Agenda Item # 7

BOA-002451-2023

APPLICATION NUMBER 6510 DATE April 3, 2023
 APPLICANT Box Owt LLC (Artious Walker, Agent)
 REQUEST Materials, Transparency, Mechanical Equipment Screening, and Frontage Type Variances

(D1) NORTH ELEVATION
1/8"=1'-0"

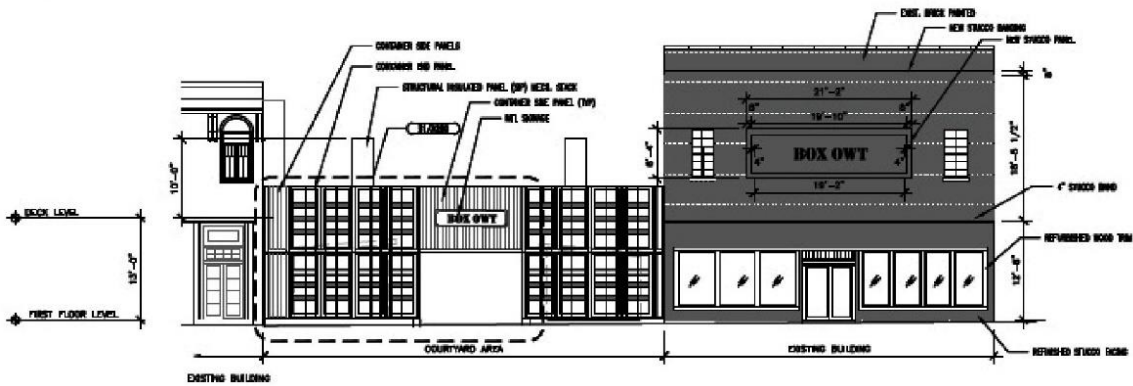
The drawings submitted for the BOA application depict two different facades. The architectural elevation depicts a façade composed of shipping container metal siding / doors with no transparency. The architectural rendering, however, depicts a different façade design which includes transparency. As such the Board has been provided conflicting information between the architectural plans and the rendering to determine what exactly will be built. Furthermore, the architectural elevation does not reflect any aspect of the approvals granted by the CRC and the ARB.

- 64-3.1.14.(g)(3) Transparency [UDC-Appendix A, Section 10.B.7.(b) and Section 10.C.4.(h)(4)a.] – no transparency.
 - *The applicant made modifications to the façade during the CRC and ARB review processes that achieved potentially compliant levels of transparency.*

- 64-3.1.14.(g)(4) Security bars [UDC-Appendix A, Section 10.B.3.(c)]– security fence/gate present across entry.
 - *The DDD specifically prohibits visible security bars on windows and doors.*

The application does not provide sufficient information to determine what will be built as a final product on the site and a holdover is in order so that accurate architectural plans can be prepared that reflect the intent of the applicant.

Once plans are prepared, they should be submitted to the Consolidated Review Committee for a review to determine compliance with the requirements of the Downtown Development District regulations, and to determine all variances that will be required for the proposed development. A resubmittal to the Architectural Review Board should also be required after the CRC has completed its review, prior to any reconsideration by the Board of Adjustment
